**CCB 8077**

**Pre and Post Change Summary**  
**PCN #: CAAN-17NSLQ806**

# Pre and Post Change Summary

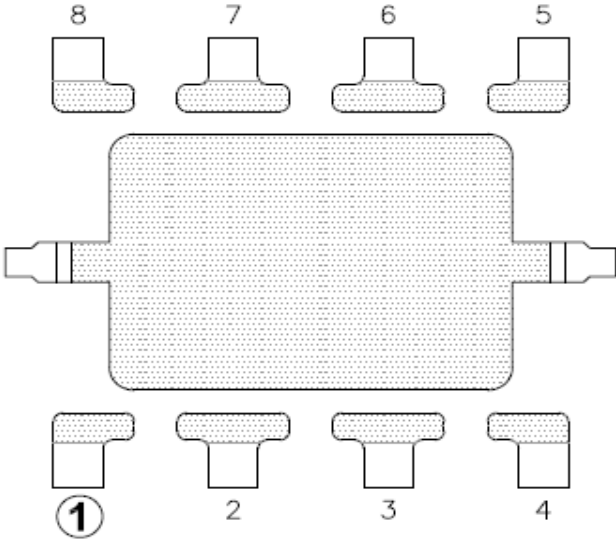
Lead-Frame Material*	CDA194																
Lead-Frame Paddle Size	90x130 mils																
Lead-Frame Lead Lock	No																
DAP Surface Prep	Ag Spot Plated																
Lead-Frame Material	A194																
Lead-Frame Paddle Size	90x90 mils																
Lead-Frame Lead Lock**	Yes (Locking Hole)																
DAP Surface Prep	Selective Ag Plated

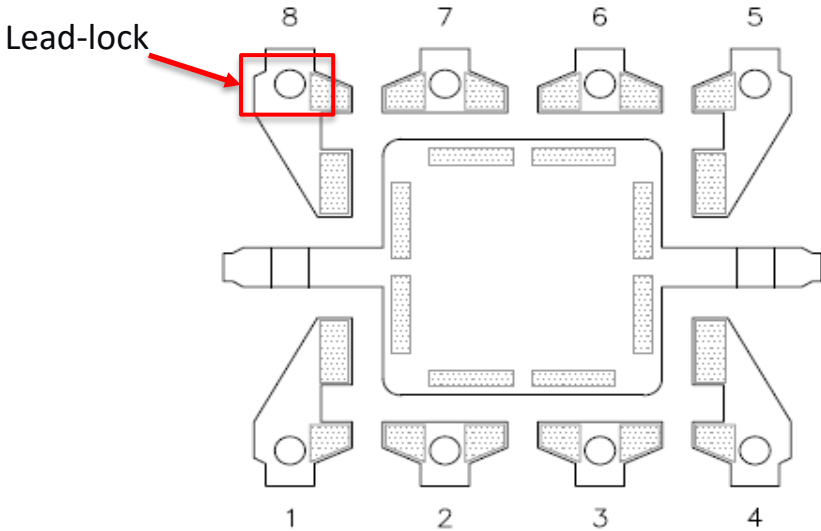
Note\*\*: Mold compound materials fills the lead-lock hole, which provides improved protection against moisture penetration along the edge of the leads (pins) of the package.
